**PROJECT NO. TMUA-W 25-07 SPAVINAW STEM WALL
MAINTENANCE**

**ADDENDUM NO. 1
TO
PROJECT NO. TMUA-W 25-07 SPAVINAW STEM WALL MAINTENANCE**

ADDENDUM 1, dated October 17, 2025

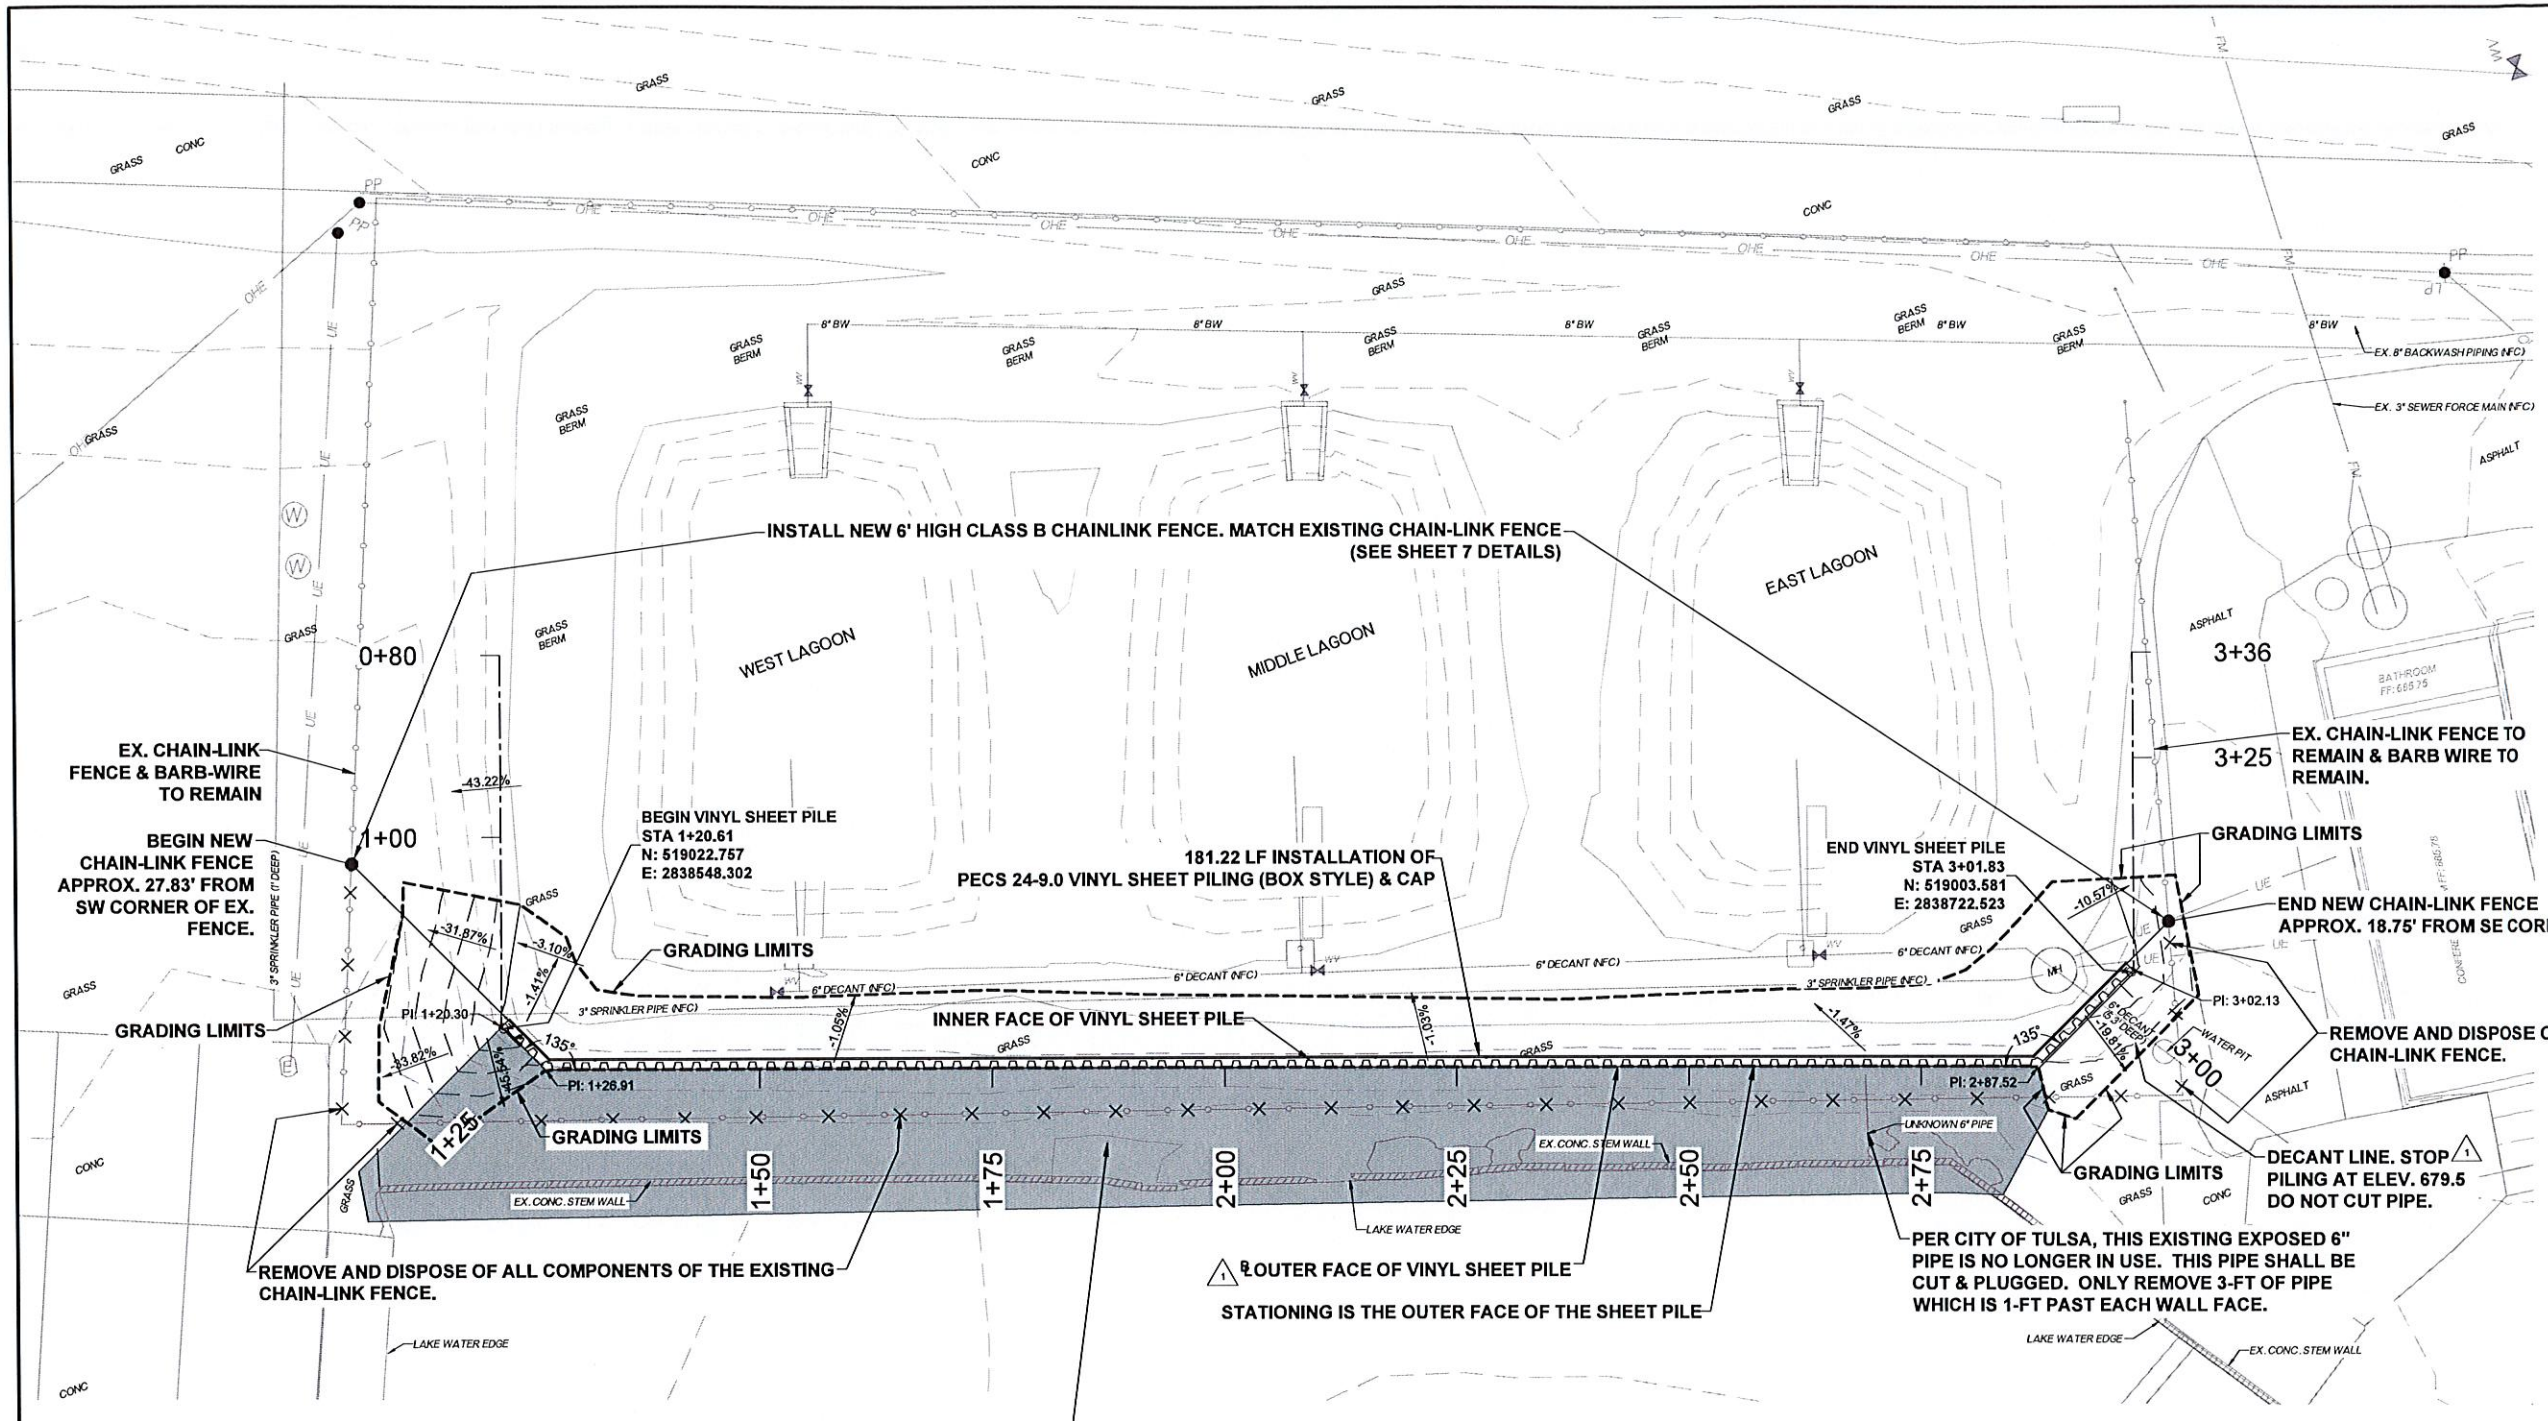
REPLACE SHEET 02 OF 15 WITH NEW SHEET WITH MODIFICATIONS LISTED BELOW:

- a. Add pay Item Note 4 – Not Used
- b. Pay Item Note 7(C) add “or in the lake” to end of the sentence.
- c. Pay Item Note 12 delete the letter E after “Owner Allowance”

- △ 4. NOT USED.
5. THE CONTRACTOR SHALL RESTORE ALL DISTURBED GRASS AREAS TO A CONDITION EQUAL TO OR BETTER THAN THE EXISTING CONDITION. THE CONTRACTOR SHALL REPLACE THE SOD TO MATCH IN-KIND AND QUALITY. ANY DISTURBANCE OUTSIDE OF GRADING SHALL BE RESTORED AT THE CONTRACTOR'S EXPENSE. THIS PAY ITEM INCLUDES ALL MOWING WITHIN THE RIGHT-OF-WAY AS DIRECTED DURING CONSTRUCTION. NETTING SHALL BE REMOVED FROM SOD PRIOR TO PLACEMENT.

7. EROSION PROTECTION SHALL BE PLACED AS FOLLOWS:
 - A) AROUND INLETS TO PREVENT INFLOW OF ERODED MATERIAL INTO STORM SEWER SYSTEM.
 - △ B) IN LOCATIONS THROUGHOUT PROJECT SITE, AS DETERMINED BY THE ENGINEER, TO PREVENT WASH OF ERODED MATERIAL ONTO ADJACENT PROPERTY OR IN THE LAKE.

11. WASTE MATERIAL TO BECOME THE PROPERTY OF THE CONTRACTOR AND SHALL BE REMOVED FROM THE SITE IN A MANNER APPROVED BY THE ENGINEER.
- △ 12. THE "OWNER ALLOWANCE CAN BE USED FOR VARIOUS WORK AND MISCELLANEOUS ITEMS NOT IDENTIFIED IN THE CONTRACT DOCUMENTS WITH THE FOLLOWING PROVISIONS:

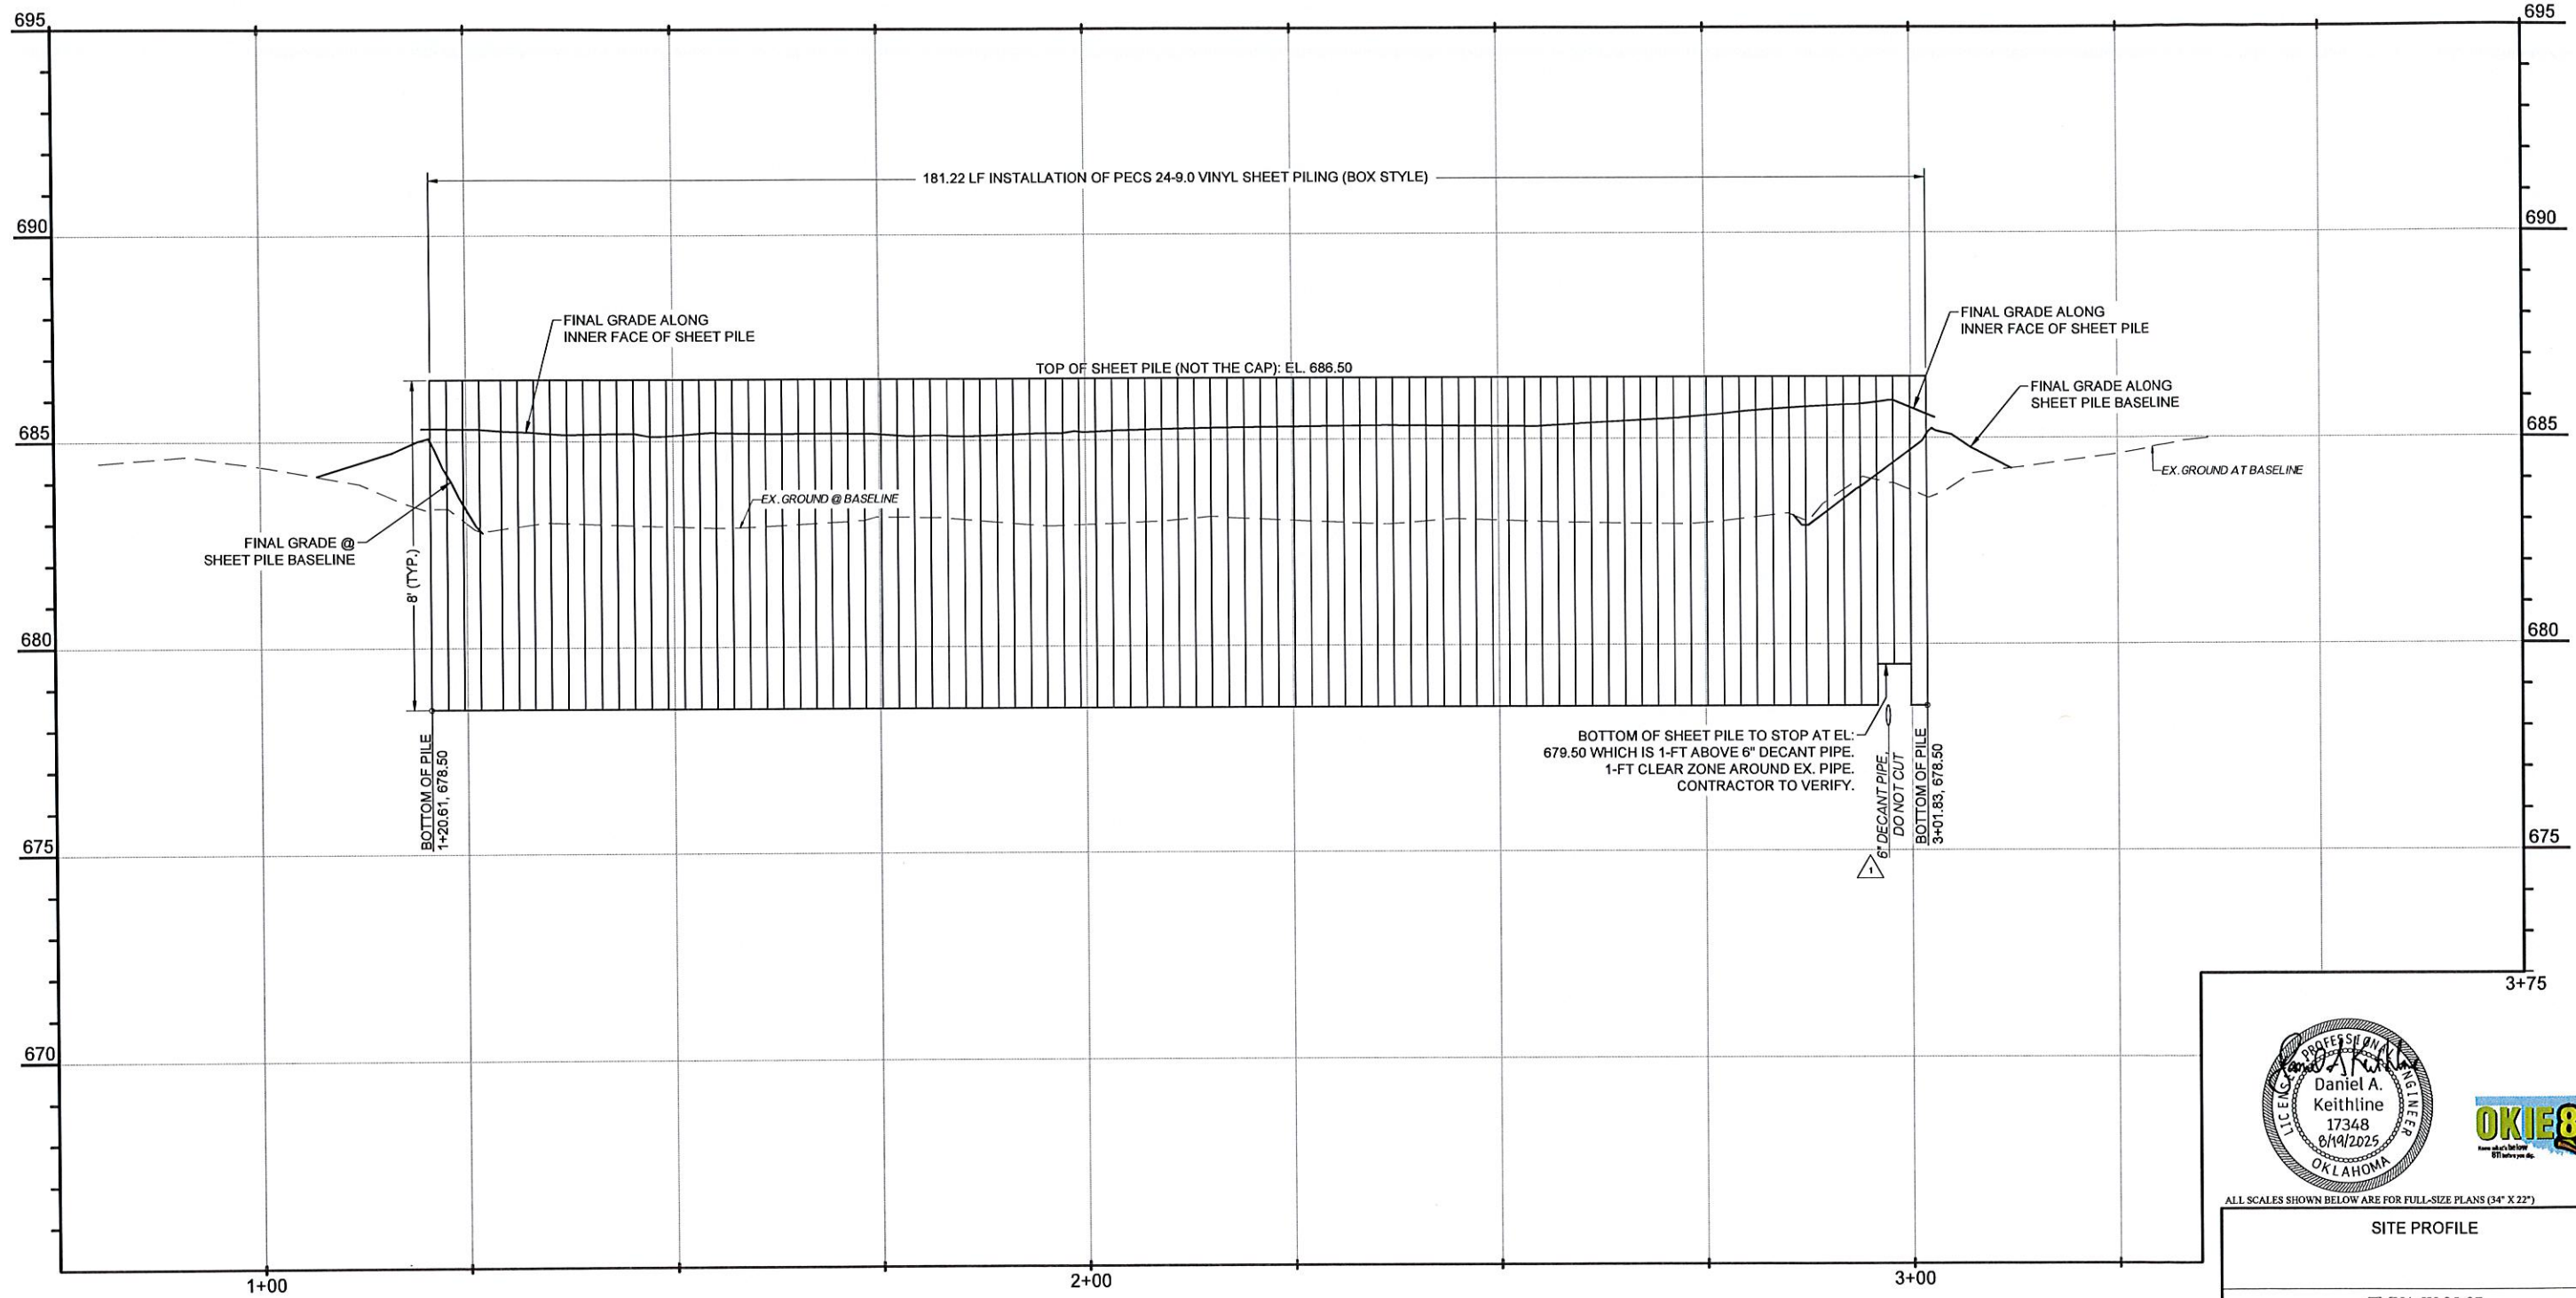
REPLACE SHEET 05 OF 15 WITH MODIFICATIONS LISTED BELOW:

- d. Change Plan Note to read “BL Outer Face of Vinyl Sheet Pile”
- e. The decant line is shown on plan and elevations. Add note “Stop piling at elevation 679.5. Do not cut decant pipe.” Contractor to field verify all pipe elevations.

△ OUTER FACE OF VINYL SHEET PILE
STATIONING IS THE OUTER FACE OF THE SHEET PILE
